LAUREL LAKE VILLAS

HUDSON, OHIO

AHBR DESIGN REVIEW
MAY 27TH, 2026

CUYAHOGA, VILLA 1 – DESIGN OPTIONS

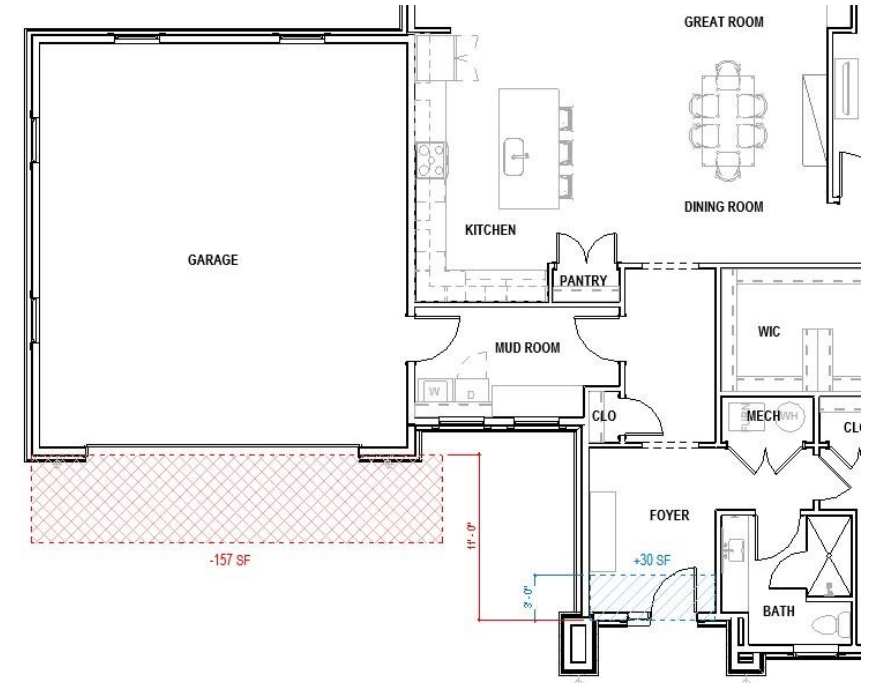
1. Section IV-3 (b)(3) – Forward facing garages.
2. Section IV-3 (b)(2) – Front Faceoff main body is 18” in front of all wings.
3. Section IV-3(b) – Main body must be largest mass.
4. Section IV-3(d)(3) – Material used must be consistent on all sides.
5. Section III-1(g)(3) – Sunroom foundation material.
6. Window trim – Consistent on all elevations.
7. Section IV-3(c) – Roof to be same shape as main body.

VILLA 2 – DESIGN OPTIONS

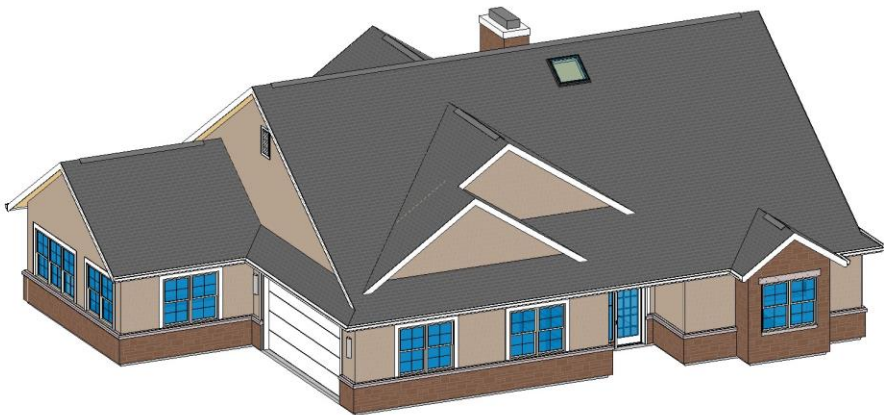
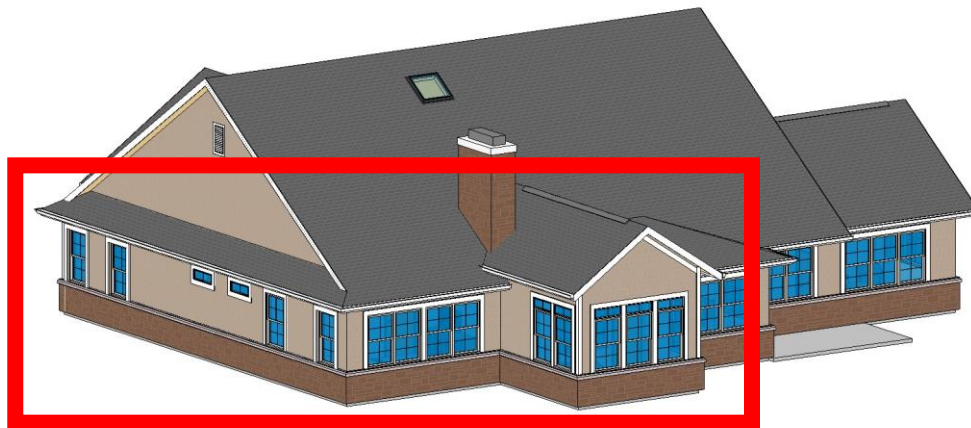
1. Section IV-3(g)(2) – 5' projections treated as wings
2. Section IV-3(e)(4) – Typical window for most windows
3. Section IV-3(f)(1) – Consistent detail applied throughout
4. Section III-1(d)(5) – Fenestration every 12'
5. Section IV-3(c) – Roof to be same shape as main body.
6. Section III-1(g)(3) – Sunroom foundation material.
7. Window trim – Consistent on all elevations.
8. Section III-1(g)(3) – Sunroom foundation material.

BRANDYWINE, VILLA 3 – DESIGN OPTIONS

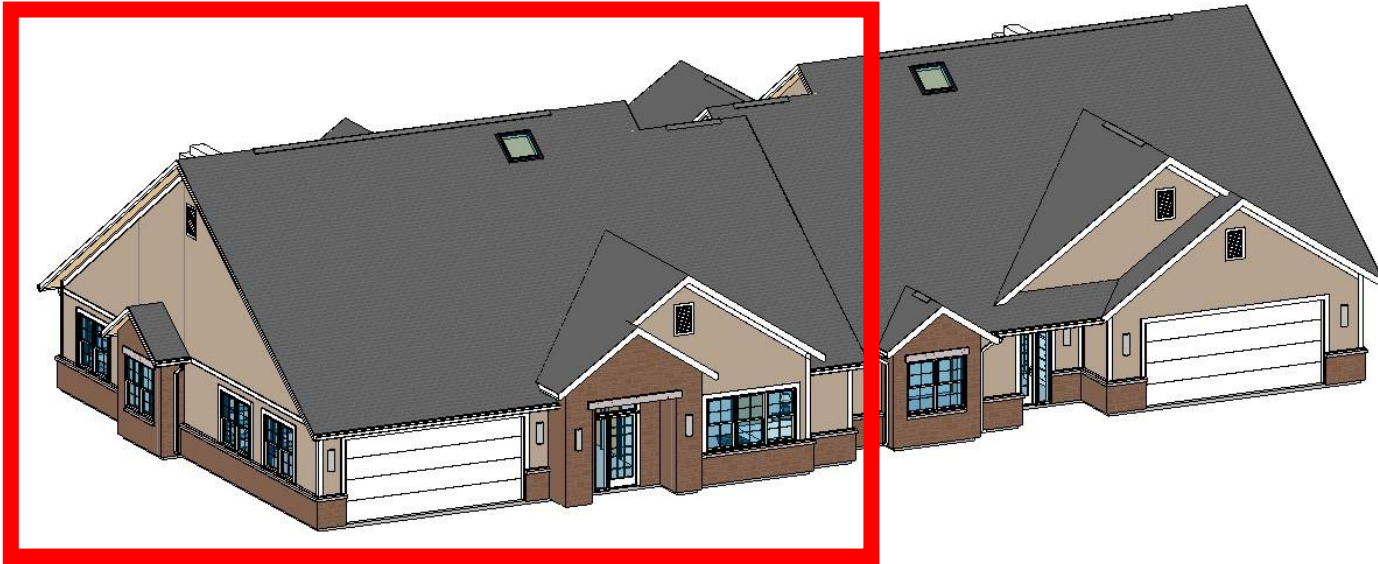
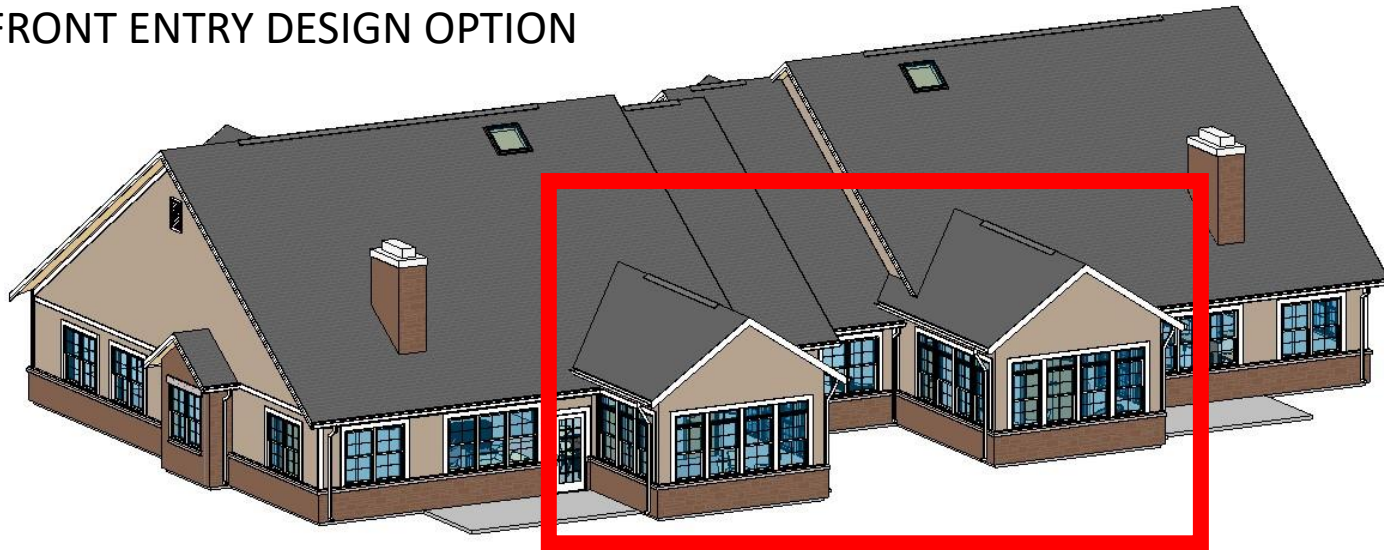
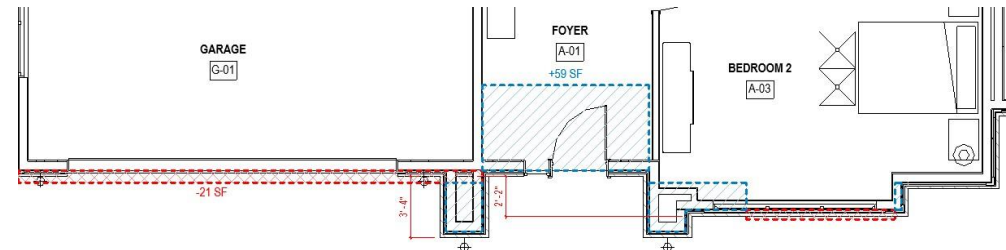
1. Section IV-3 (b)(3) – Forward facing garages.
2. Section IV-3 (b)(2) – Front Faceoff main body is 18” in front of all wings.
3. Section IV-3(g)(2) – 5’ projections treated as wings
4. Section III-1(d)(5) – Fenestration every 12’
5. Section IV-3(c) – Roof to be same shape as main body.
6. Section III-1(g)(3) – Sunroom foundation material.
7. Window trim – Consistent on all elevations.

1. Section IV-3 (b)(3) – Forward facing garages.
2. Section IV-3 (b)(2) – Front Faceoff main body is 18” in front of all wings.
3. Section III-1(d)(5) – Fenestration every 12’
4. Section IV-3(c) – Roof to be same shape as main body.
5. Section III-1(g)(3) – Sunroom foundation material.
6. Window trim – Consistent on all elevations.

VILLA 5 – DESIGN OPTIONS

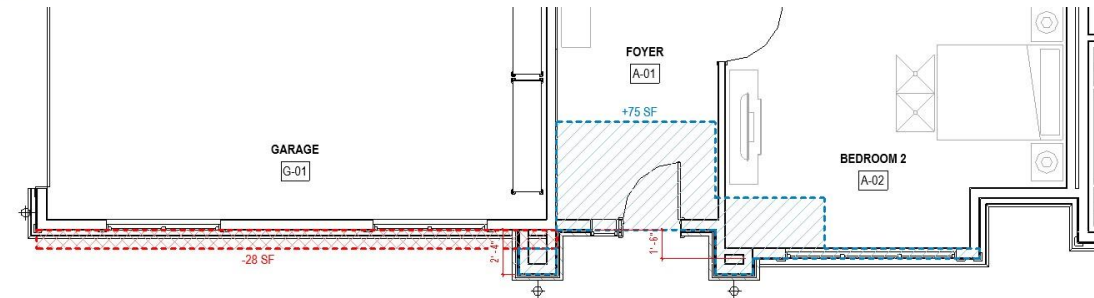
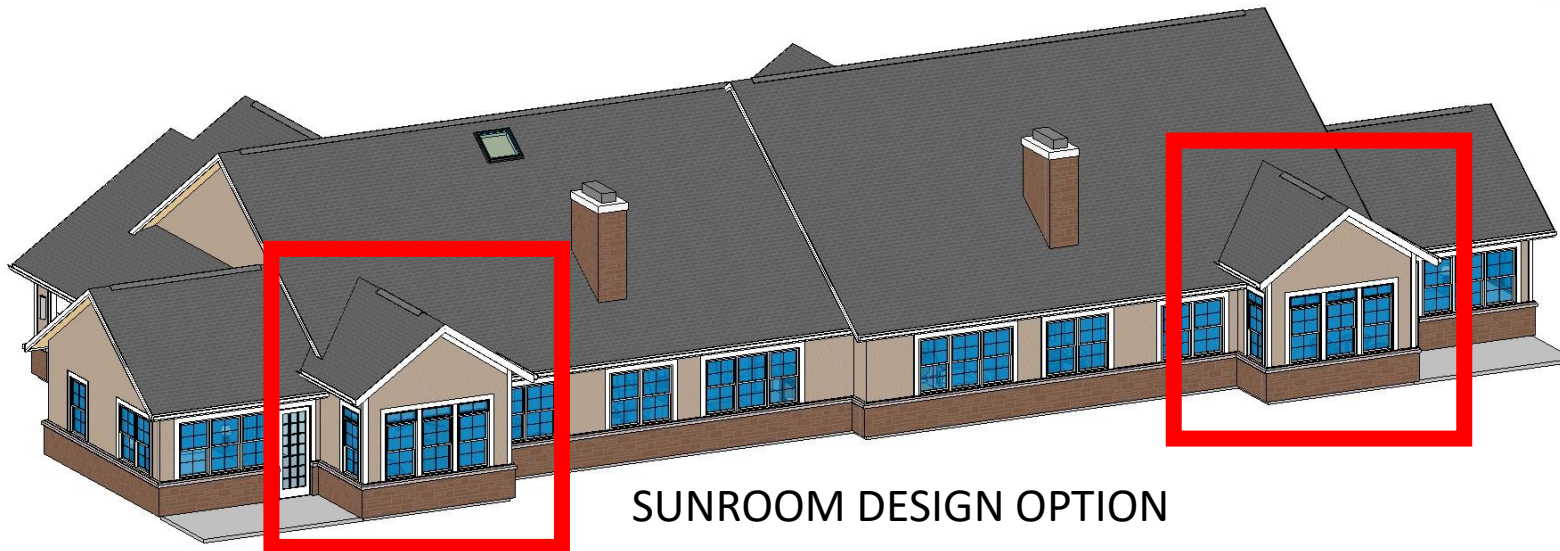
1. Section IV-3 (b)(3) – Forward facing garages.
2. Section IV-3(g)(2) – 5' projections treated as wings
3. Section III-1(g)(3) – Sunroom foundation material.
4. Section IV-3(f)(1) – Consistent detail applied throughout
5. Section IV-3(c) – Roof to be same shape as main body.
6. Section III-1(g)(3) – Sunroom foundation material.
7. Window trim – Consistent on all elevations.

CASCADE, VILLA 8 & 9 – DESIGN OPTIONS

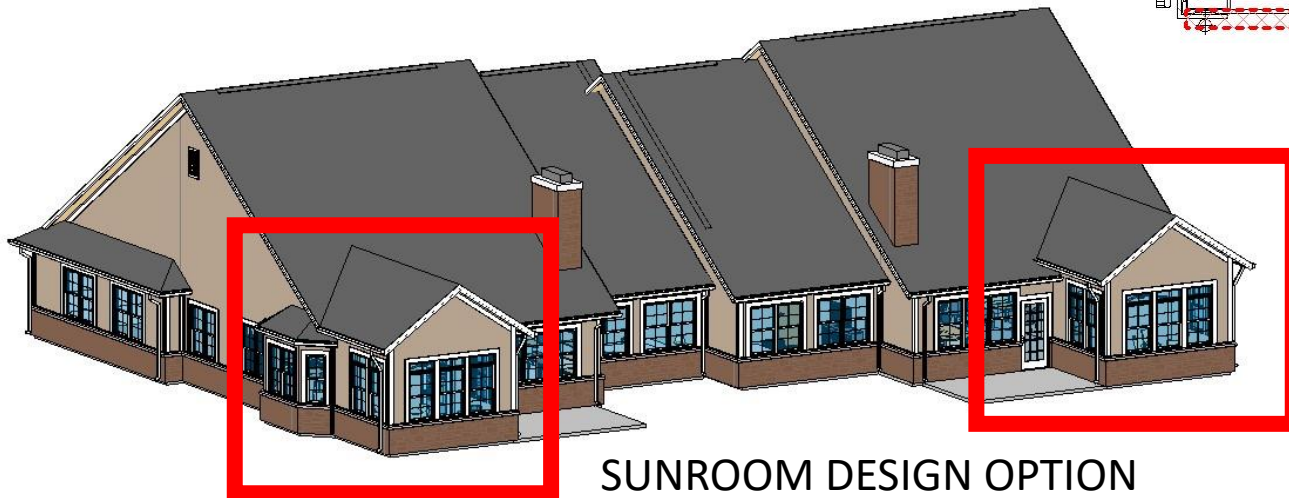
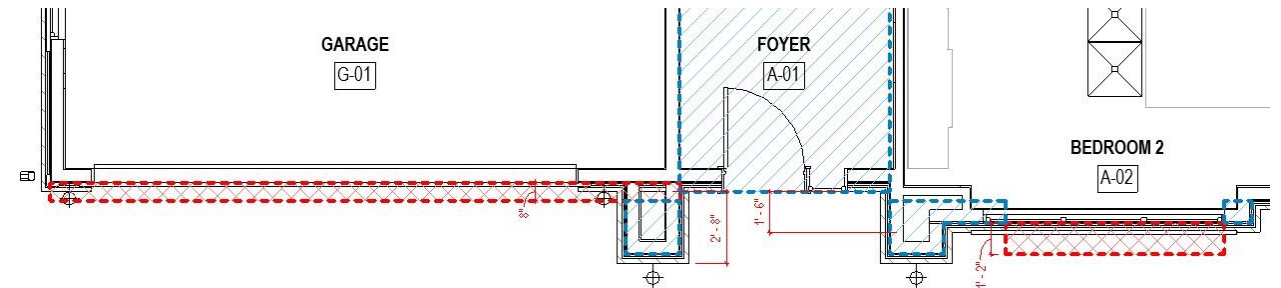
1. Section IV-3 (b)(3) – Forward facing garages.
2. Section IV-3 (b)(2) – Front Faceoff main body is 18" in front of all wings.
3. Section III-1(d)(5) – Fenestration every 12'
4. Section IV-3(c) – Roof to be same shape as main body.
5. Section III-1(g)(3) – Sunroom foundation material.
